Date: June 22, 2023
Refer To: N3B-2023-0209

Subject: Submittal of the Response to the U.S. Environmental Protection Agency National Pollutant Discharge Elimination System Permit No. NM0030759 Los Alamos National Laboratory Stormwater Individual Permit Comments on 2022 Annual Sampling Implementation Plan

1. 2022 Annual Sampling Implementation Plan NPDES Permit No. NM0030759 June 2023 (EM2023-0377, EM2023-0378, EM2023-0379, EM2023-0380, EM2023-0381, and EM2023-0382)
2. Response to the U.S. Environmental Protection Agency’s NPDES Permit No. NM0030759 Los Alamos National Lab. (LANL) Stormwater Individual Permit Comments on Sampling Implementation Plan (SIP), Dated May 2, 2023 (EM2023-0383)

Figure 3.3-1 Inorganics Analytical Results from Soil Samples Associated with R-SMA-2.3

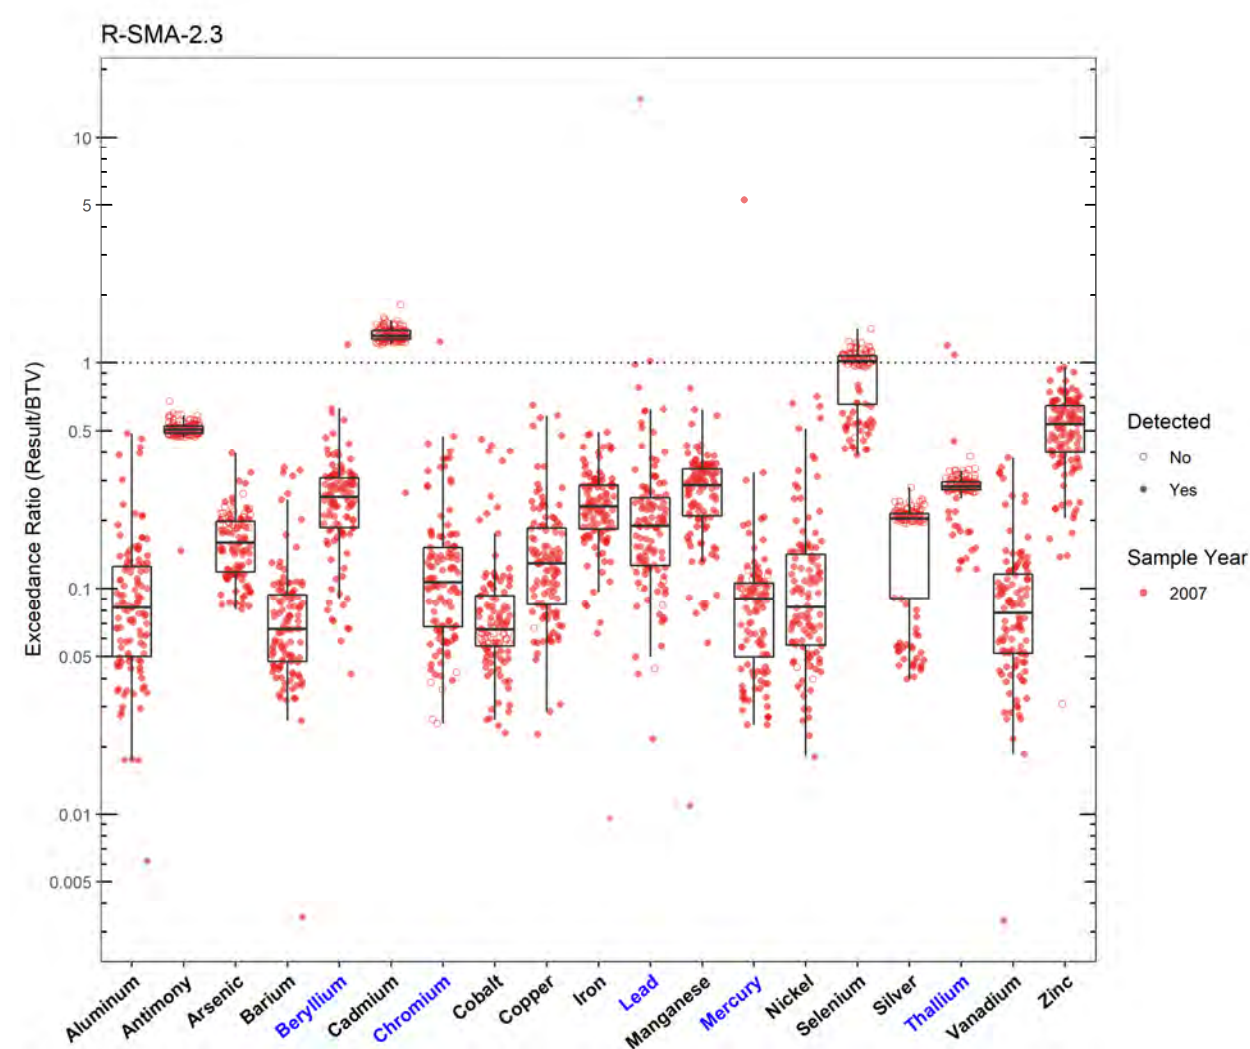
6. **Site Deletion: Sites that have soil and BTV exceedances should not be eligible for site deletion. For example, R-SMA-2.3 shows soil exceedances for beryllium, chromium, lead, mercury, and thallium (Figure 3.3-1 in the SIP), and BTV exceedances for cobalt, zinc, nickel yet it is being proposed for site deletion. Site CDV-SMA-6.02 has soil exceedances for cadmium, lead, selenium, and zinc and a BTV exceedance for cobalt and is also being proposed for site deletion.**
